Re: Uungula Wind Farm (SSD6687) Response to Request for Information 3 April 2021

Request for Information (RFI): Ungula Wind Farm

Figure 1: Ancillary Structures

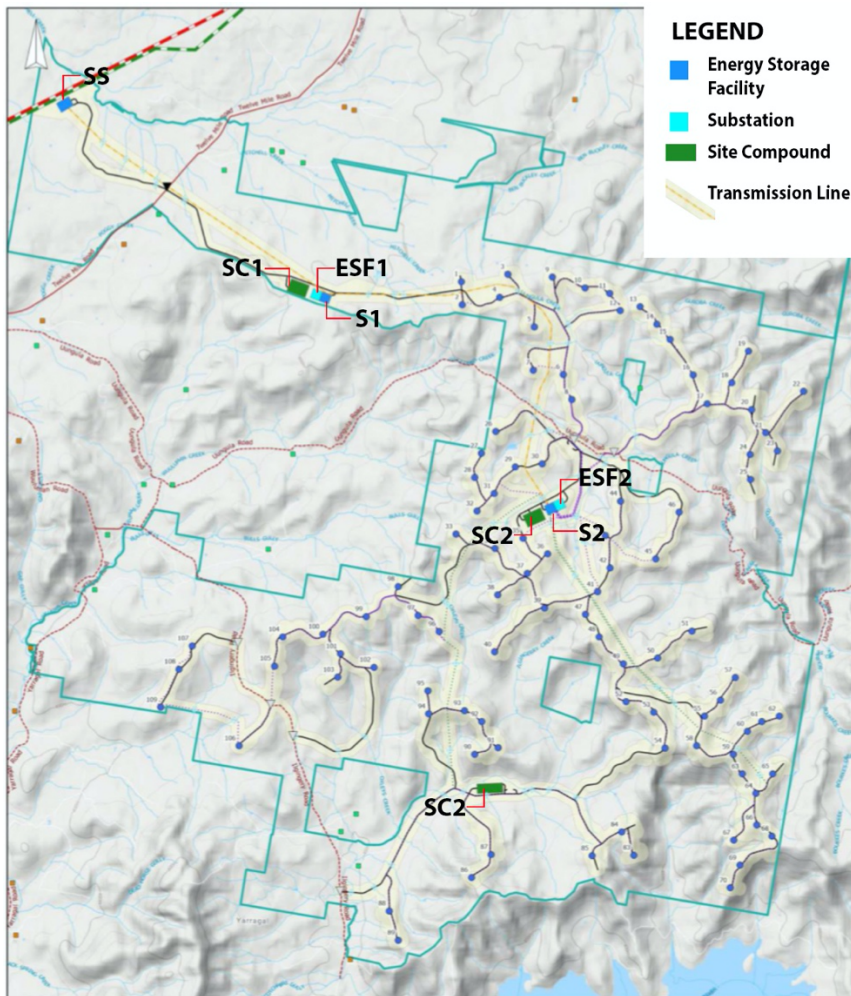
This letter provides further clarification as requested in the Request for Information (RFI) dated 3rd April 2021 requesting additional information relating to the visual impact of the following:

Two possible locations of the Energy Storage Facility (ESF) have been identified for the Project, both of which are located adjoining the proposed substations sites. For the purpose of this assessment, the ESF locations have been referred to as ESF1 and ESF2 (see **Figure 1**).

ESF1 is likely to be visible in the distance from two dwellings to the north (TMR023 and TMR031). Due to the existing intervening vegetation and the distance to the ESF1, the visual impact is likely to be low. Screen planting is recommended along the northern boundary of the proposed ESF1 to completely screen views from dwellings to the north. The extent of screen planting required will be determined during the detailed design phase.

Views to ESF2 would be contained from Ungula Road by roadside vegetation. The potential visual impact is nil.

Three Site Compounds are proposed for the Project (referred to as SC1, SC2 & SC3 – See **Figure 1**).

SC2 and SC3 are located on isolated land with limited opportunities to view. There will be no visual impact from non-involved dwellings or publicly accessible land resulting from these Site Compounds and therefore the visual impact is negligible.

SC1 is located within 5000 m of four non-involved dwellings (TMR032, TMR030, TMR023 and TMR031). Views to SC1 would be screened by topography from TMR032 and TMR030. Views to the SC1 may be visible from TMR023 (2.83 kms north of the SC1) and TMR031 (2.80 kms north of SC1). A combination of existing intervening vegetation and distance would fragment and diminish views. It is our opinion that the potential visual impact of SC1 is low. Screen planting is recommended to the north of SC1 to completely screen views from the dwellings resulting in a negligible visual impact. The extent of screen planting required will be determined during the detailed design phase.
